To : ALL	Doc. No.	SECYMM-XX-X
C.C. :	Country	ALL
From: Hyung-il Park	Tel: 82-31-279-3252	Fax:
	E-mail: <a href="mailto:hipark@samsung.com">hipark@samsung.com</a>	
Subject : OfficeServ7000 S/W V4.99 (2016.09.30) release

## OfficeServ 7000 series MP S/W release

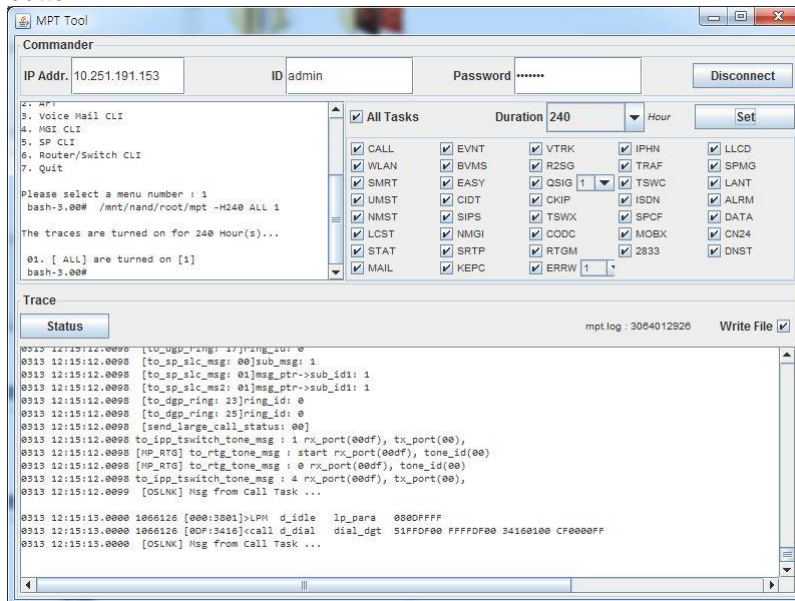
User can check and save trace data from remote with MPT Tool.

If you want to connect over public IP address, you should open telnet port 23 and TCP port 5030. And in case of OS7400 and OS7200, you should add mptTool.jnlp, mptTool\_public.jnlp and mptTool.jar files to /DM directory in SD card.

For more details, refer to the below description.

- Input PC IP Address to Management IP White List in DM 5.13.11.
